PUD MINOR MODIFICATION
COMPARISON

1270 4TH ST NE WASHINGTON, DC

MARCH 14, 2016

CURRENT DESIGN: MAR 14 2016
PENTHOUSE PLAN

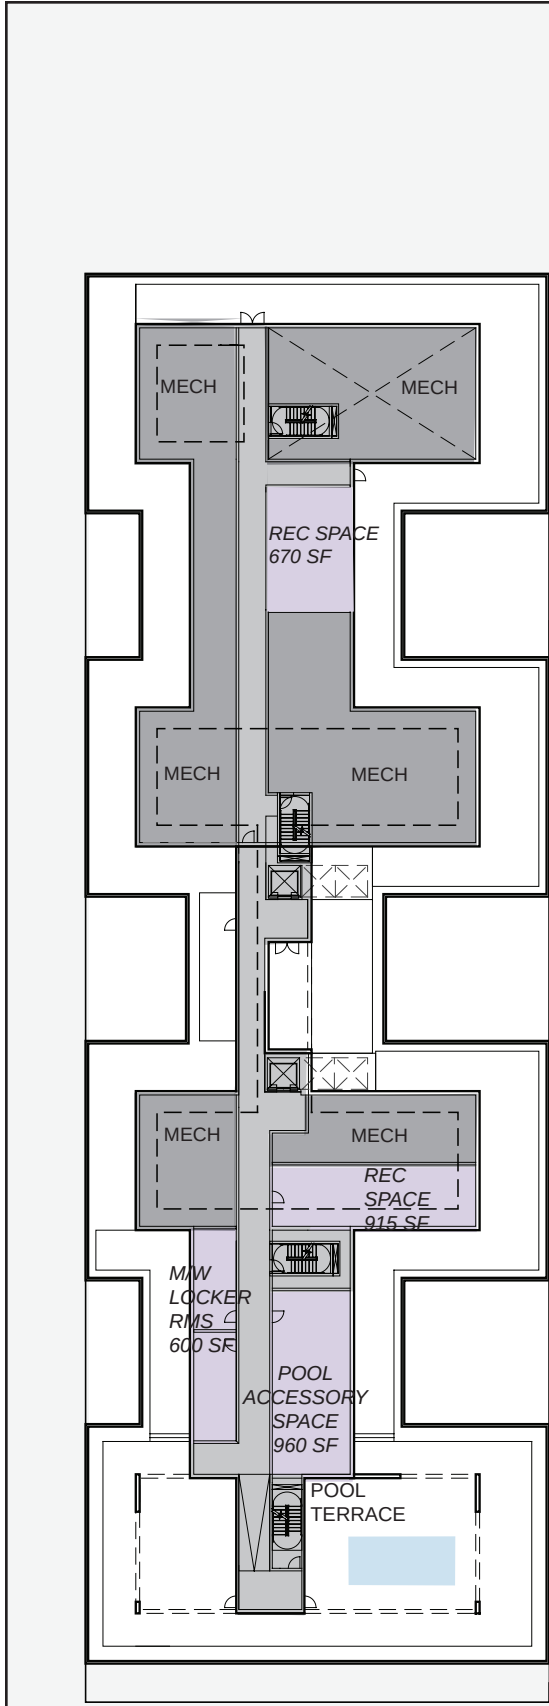
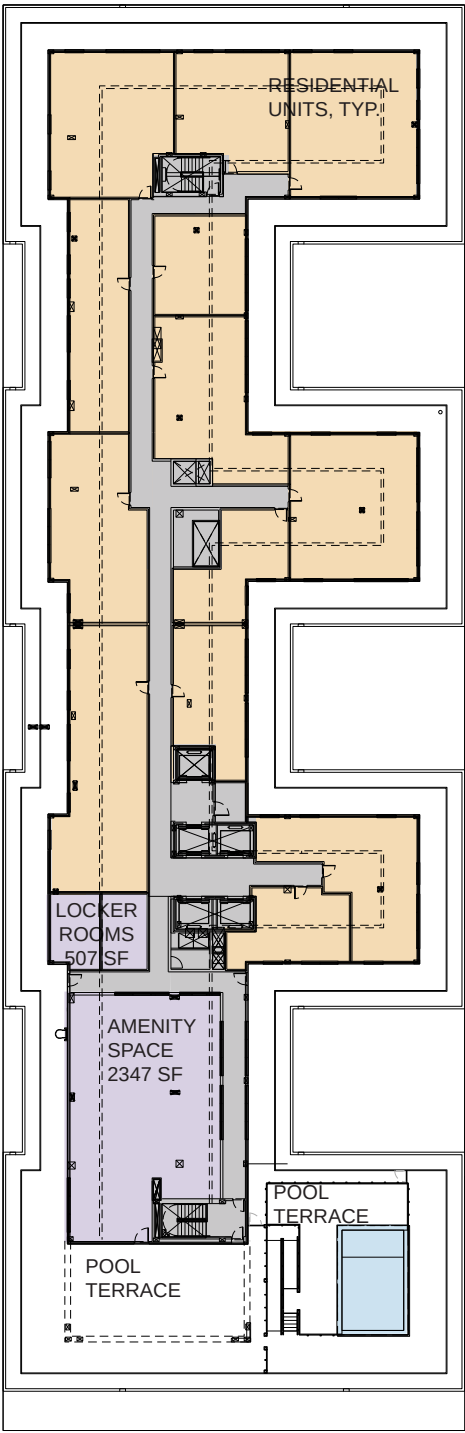
GROSS AREA TABULATIONS:	
PUD	CURRENT
16,834 SF	20,250 SF SEE NOTE 1, 2

1. 15,280 SF OF THIS 20,250 SF IS RESIDENTIAL HABITABLE AREA (UNITS, CORRIDORS, AND SUPPORTING SPACE), FOR A TOTAL OF 0.227 FAR OF HABITABLE SPACE ON RECORD LOT.
2. PENTHOUSE RESIDENTIAL HABITABLE AREA GENERATES AN ADDITIONAL 1,222 GSF OF AFFORDABLE UNIT AREA AT 50% AMI, TO BE DISTRIBUTED IN ACCORDANCE WITH OTHER 50% AMI UNITS ON SITE.

CURRENT DESIGN: MAR 14 2016
MECHANICAL MEZZANINE PLAN

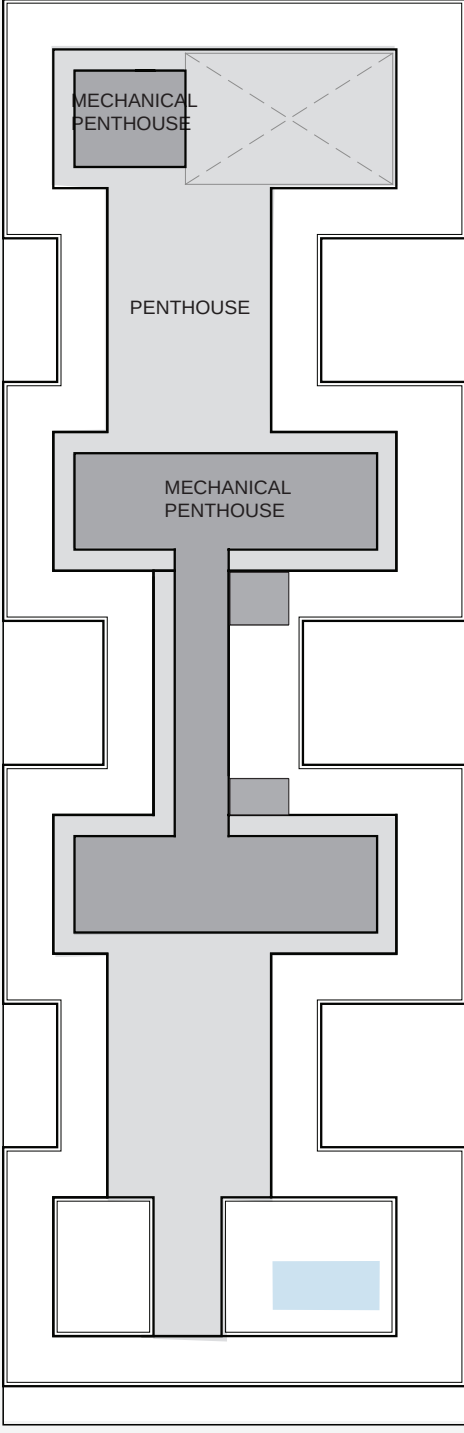
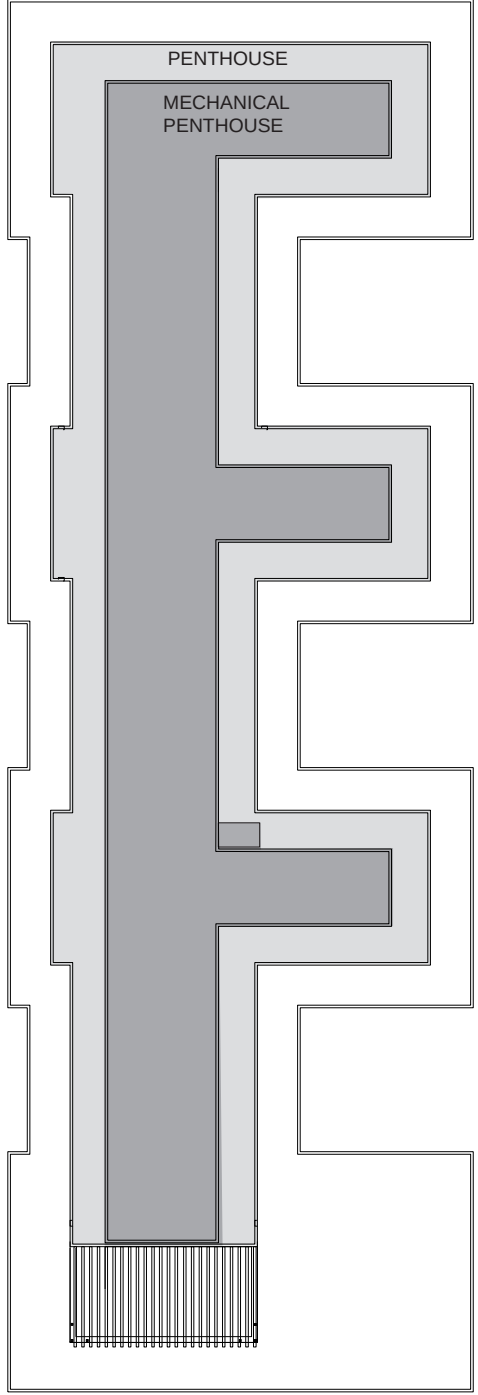
GROSS AREA TABULATIONS:	
PUD	CURRENT
5,685 SF	11,501 SF

1. NO CHANGE TO GAR.

REVISIONS TO GARAGE PLAN:

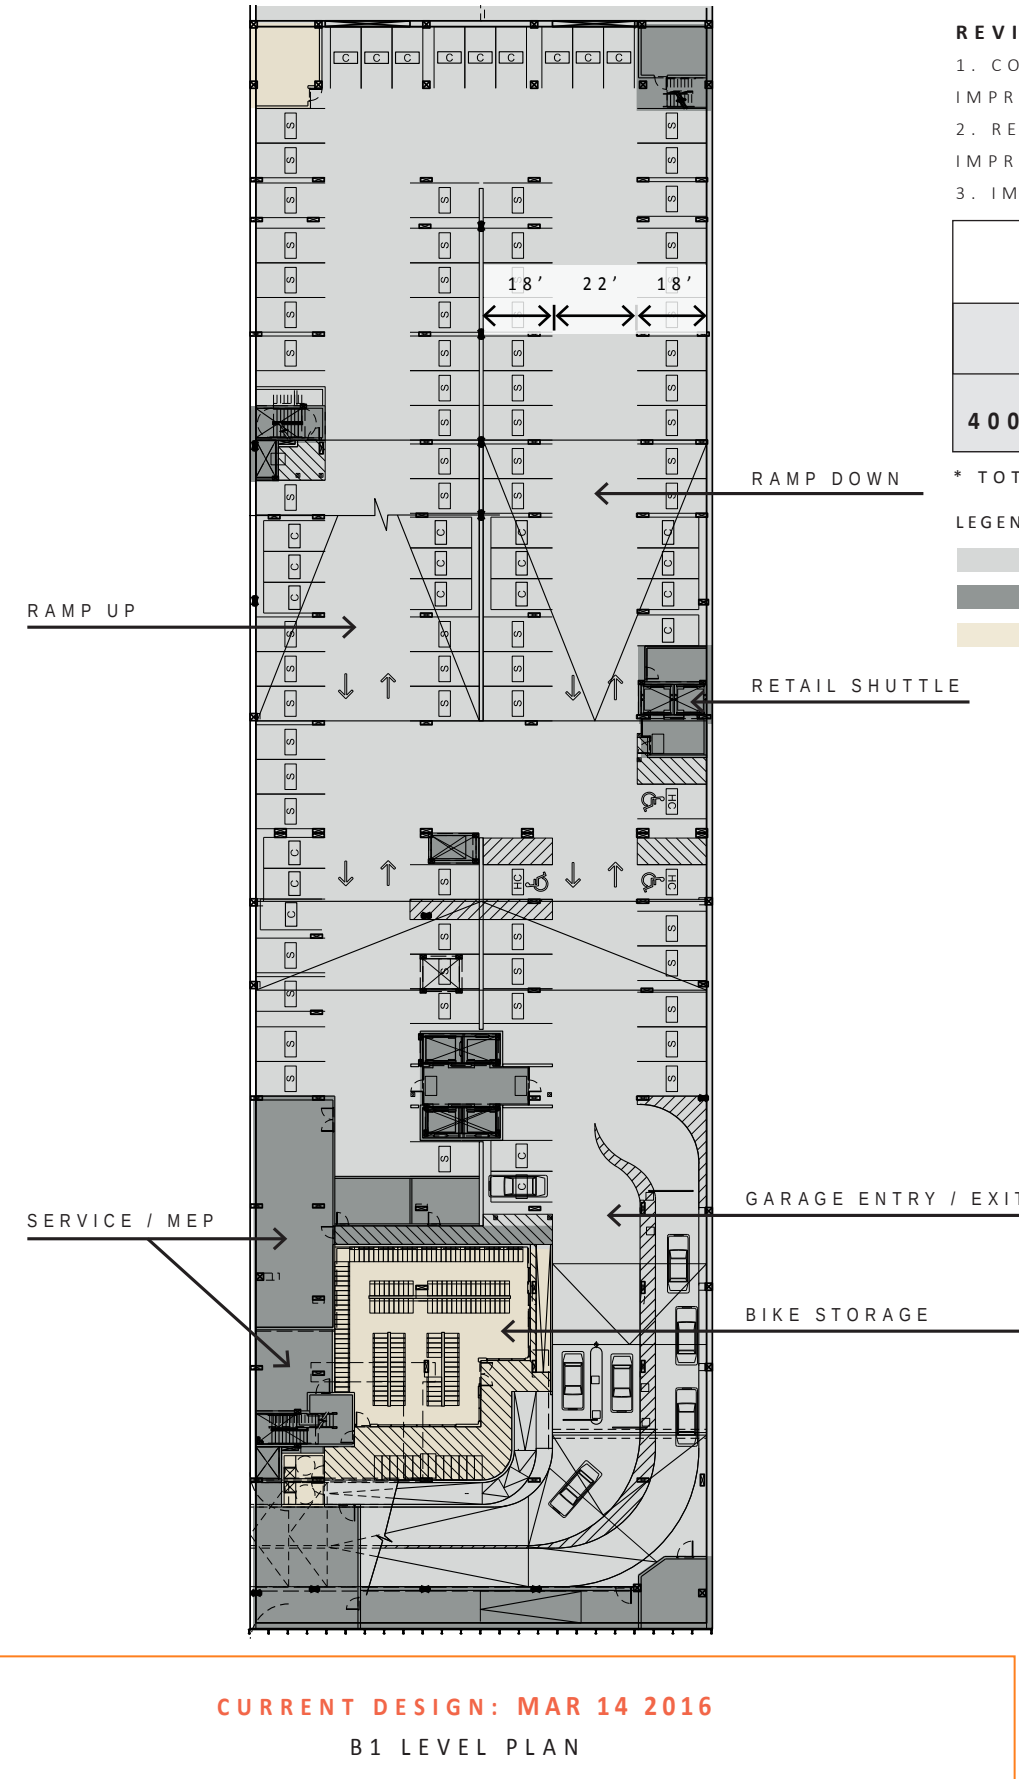
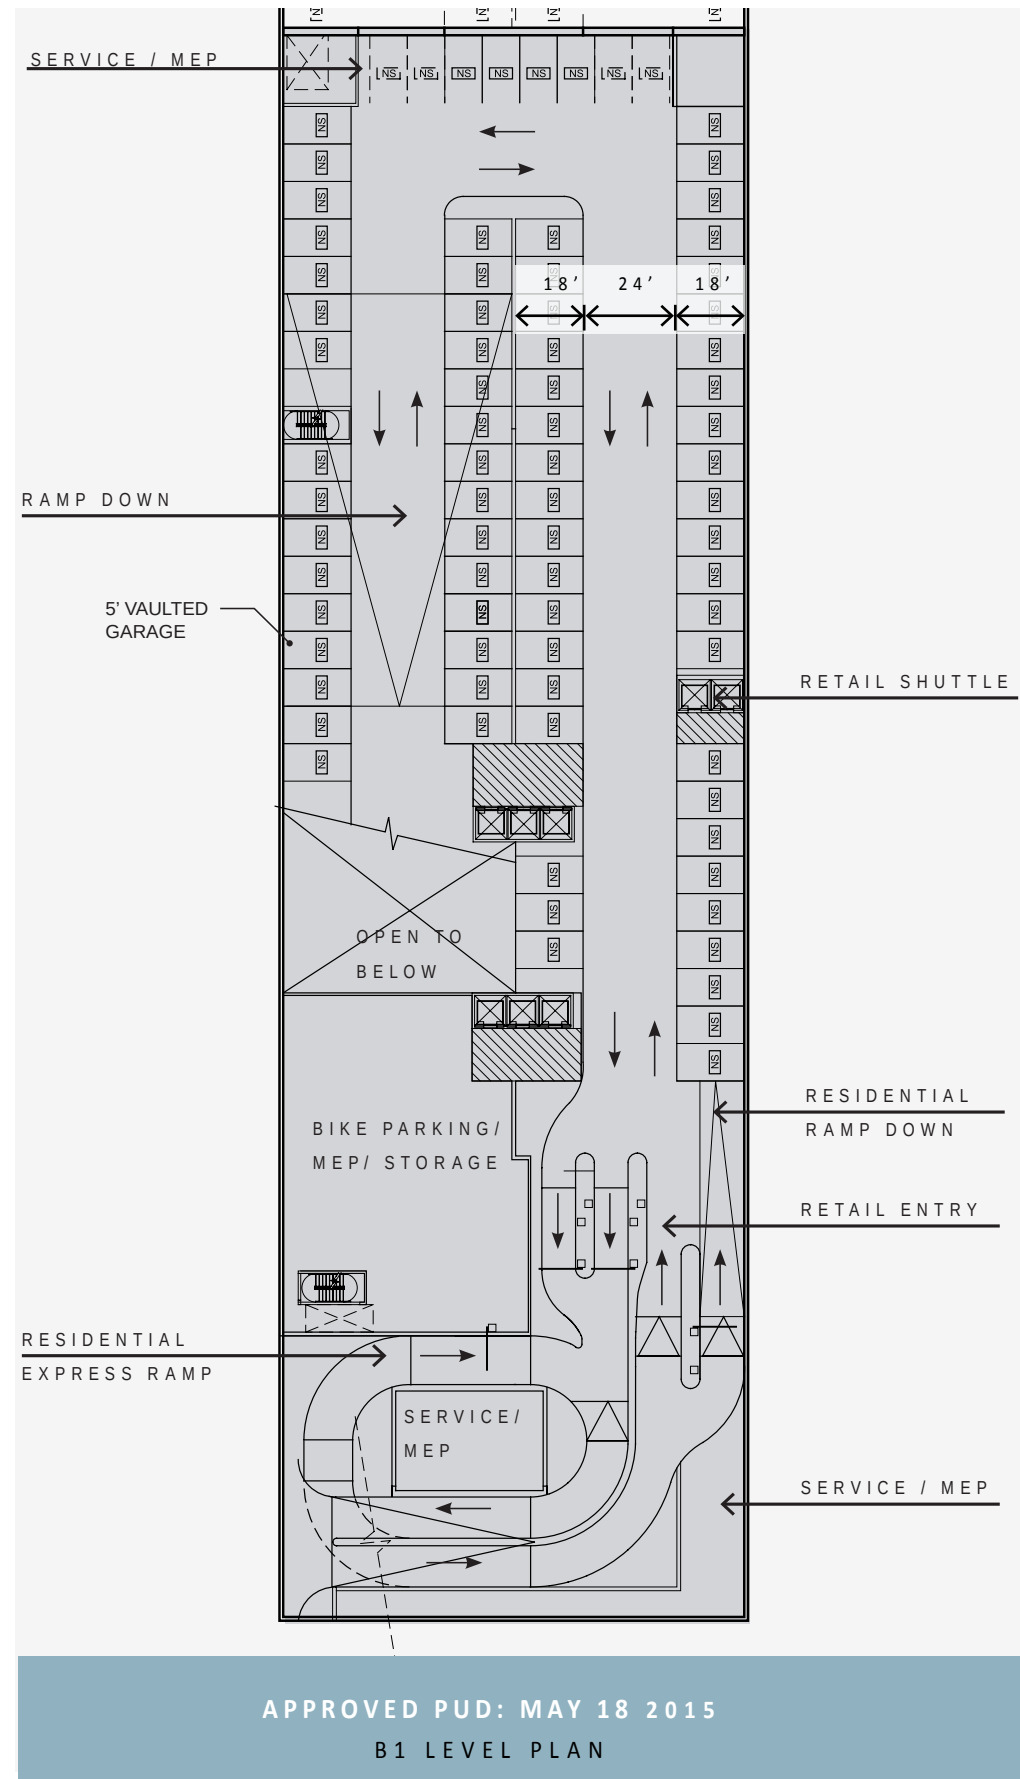
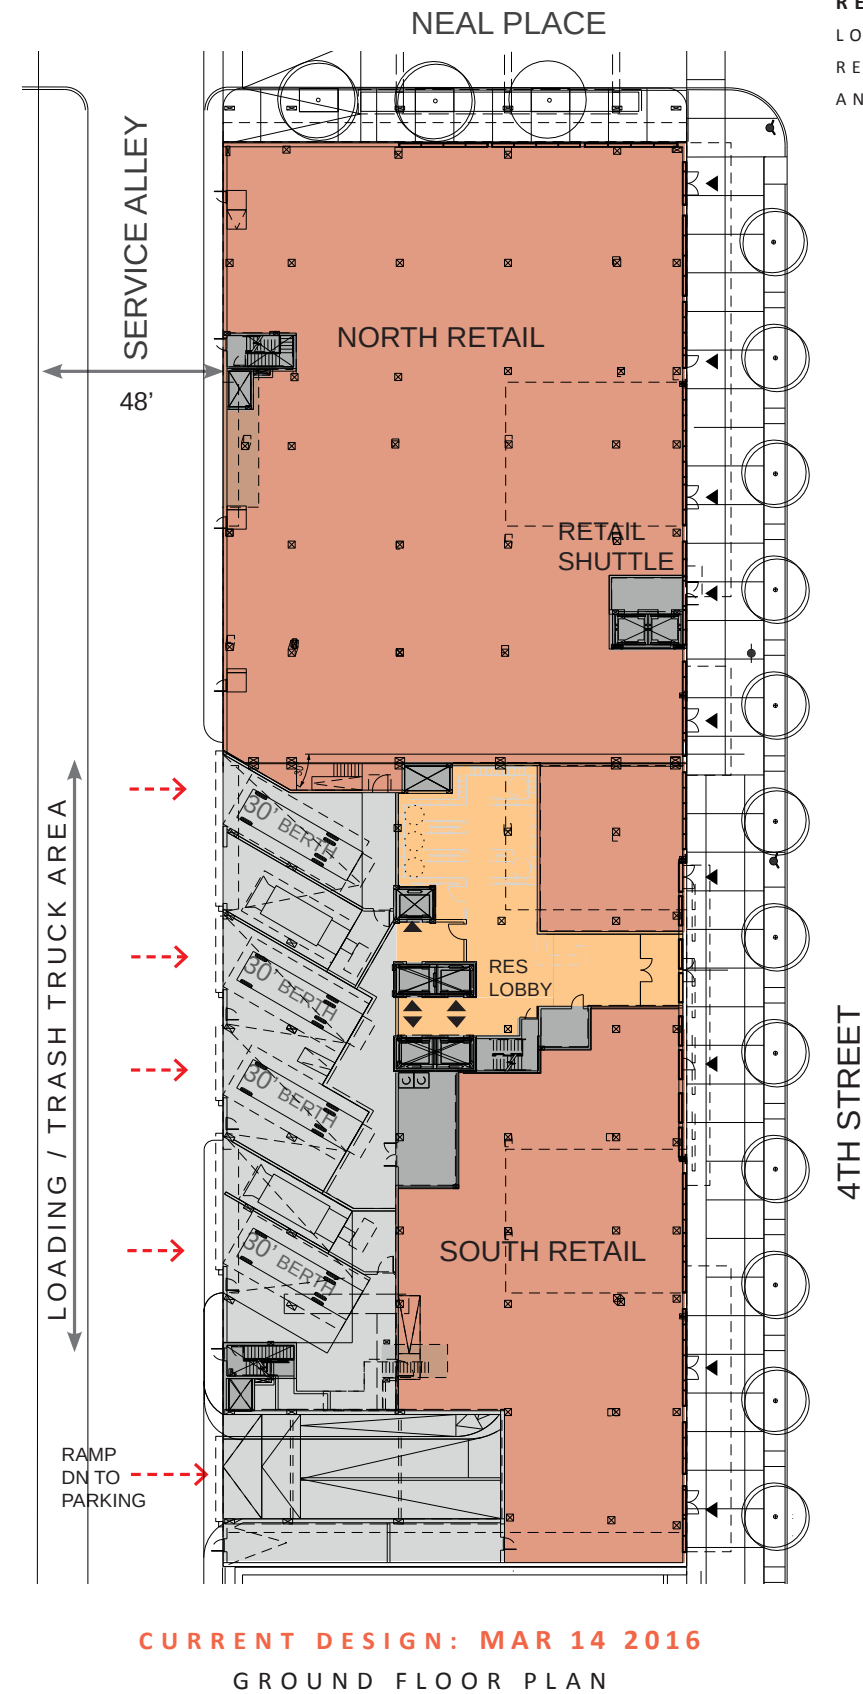
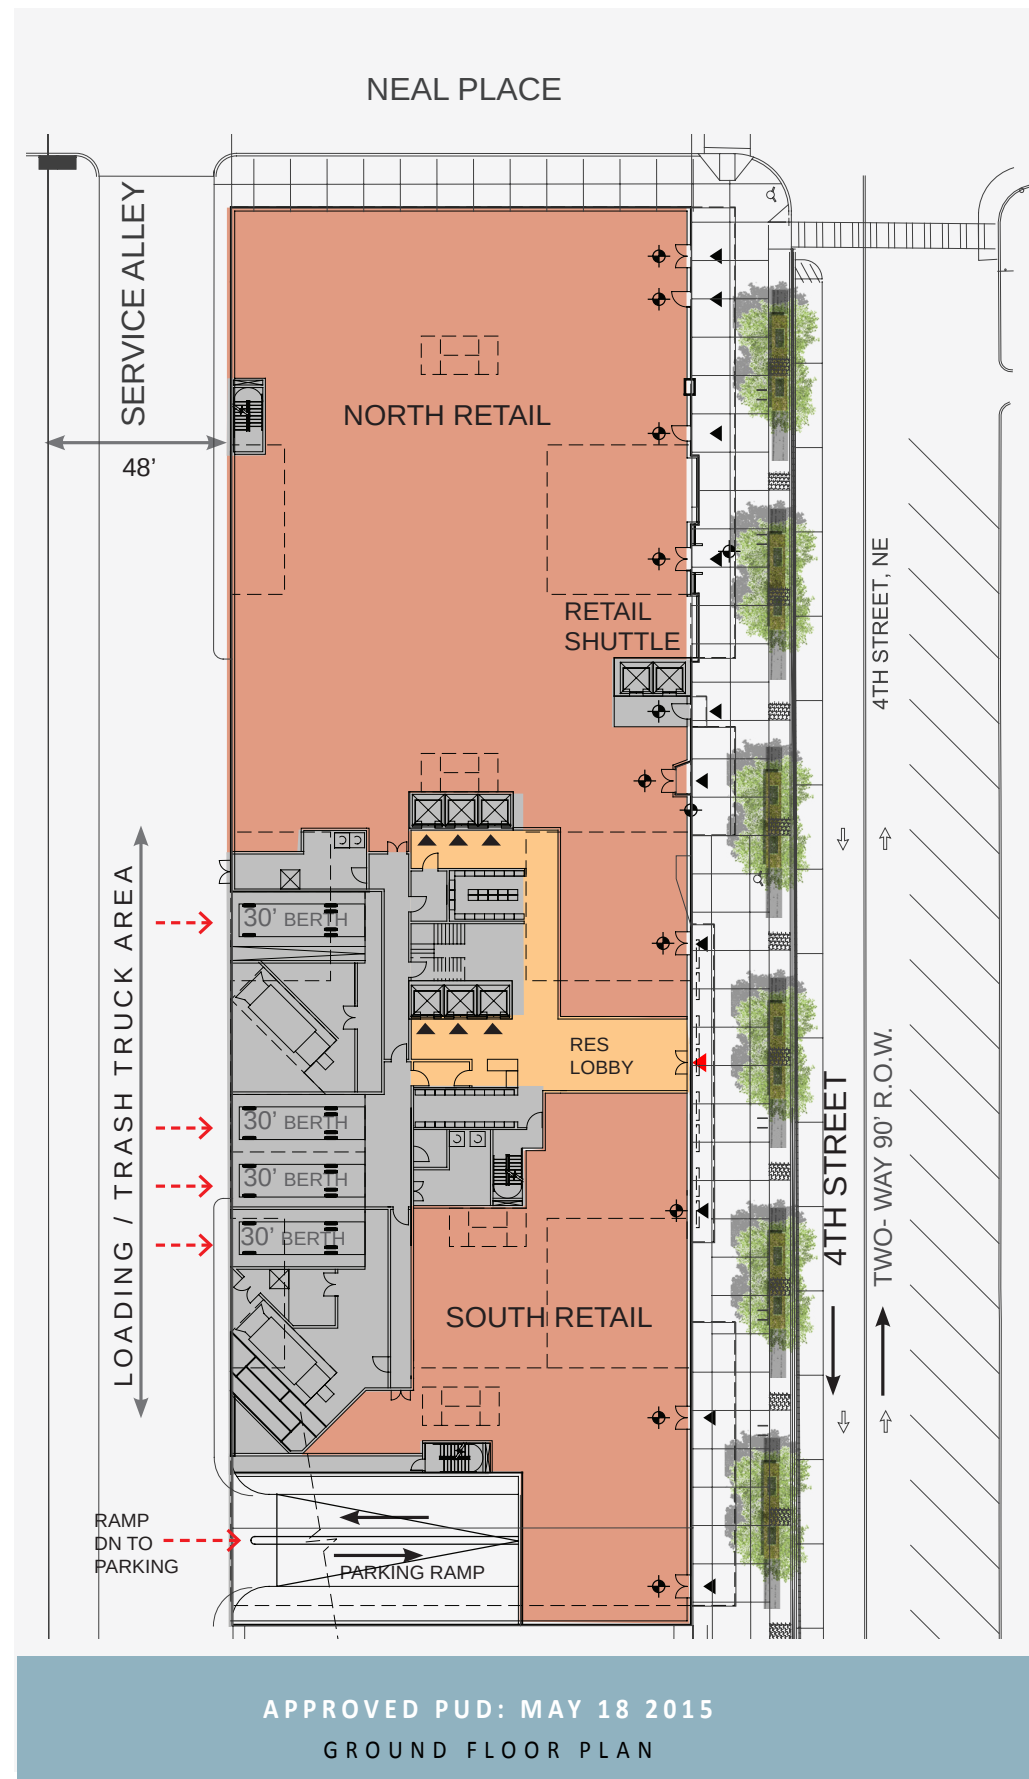
1. CONSOLIDATION OF GARAGE RAMPS TO IMPROVE EFFICIENCY.
2. RECONFIGURATION OF GARAGE AISLES TO IMPROVE EFFICIENCY.
3. IMPROVE BICYCLE ACCESS.

PUD	CURRENT
400-550 SPACES	400-430 SPACES *

CURRENT DESIGN: MAR 14 2016
TYPICAL FLOOR PLAN

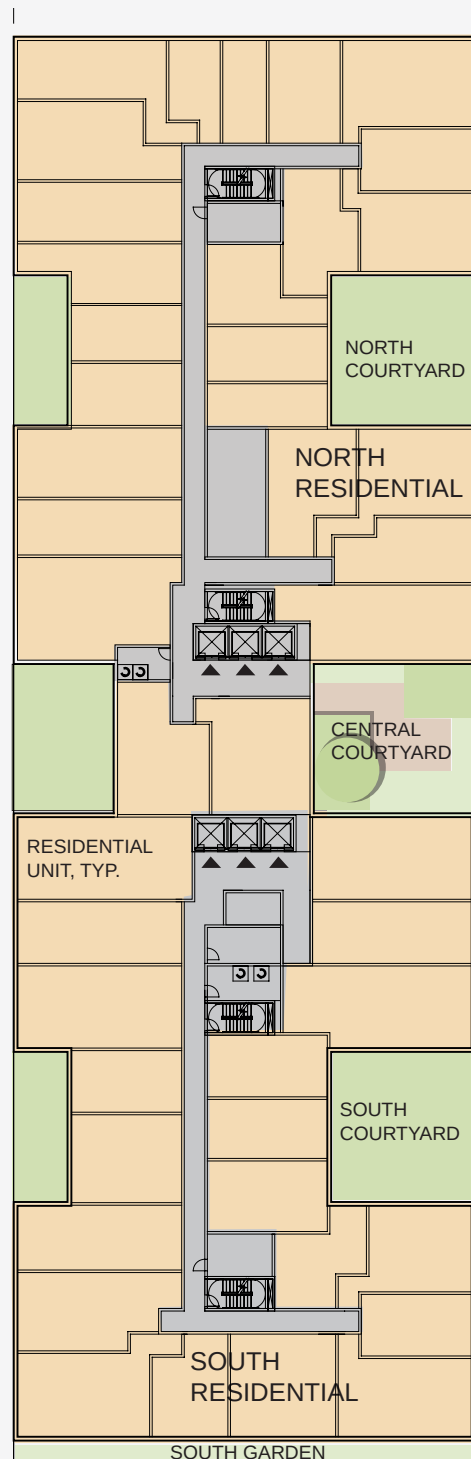
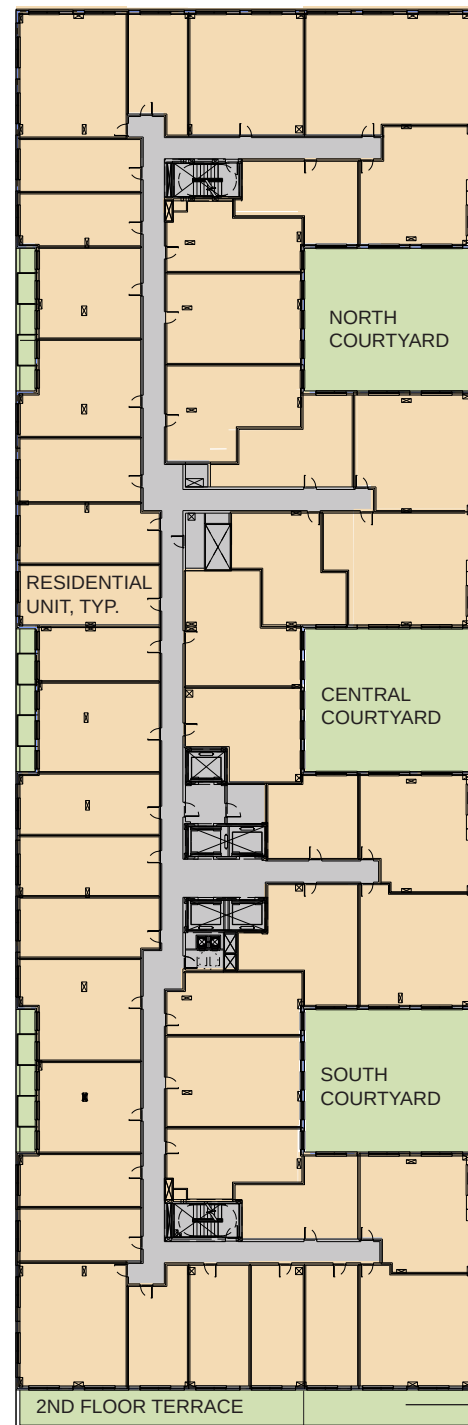
REVISIONS TO GROUND FLOOR PLAN
LOADING BERTH, SERVICE AREA AND GROUND FLOOR
RECONFIGURATION TO ACCOMMODATE RESIDENTIAL
AND RETAIL PROGRAM AND IMPROVE EFFICIENCY.

1. PAGE INCLUDED FOR ILLUSTRATIVE PURPOSES; NO MODIFICATION APPROVAL REQUESTED FOR THE TYPICAL FLOOR PLAN DESIGN. THIS PAGE IS INTENDED TO DEPICT UPDATED UNIT DEMISING AND FLOOR LAYOUT AS DESIGN DRIVER FOR EXTERIOR FACADE AND COURT CHANGES, PER PAGES 2,3,4, AND 5.
2. REFINED FLOOR PLAN TO ACCOMMODATE RESIDENTIAL PROGRAM AND IMPROVE EFFICIENCY.
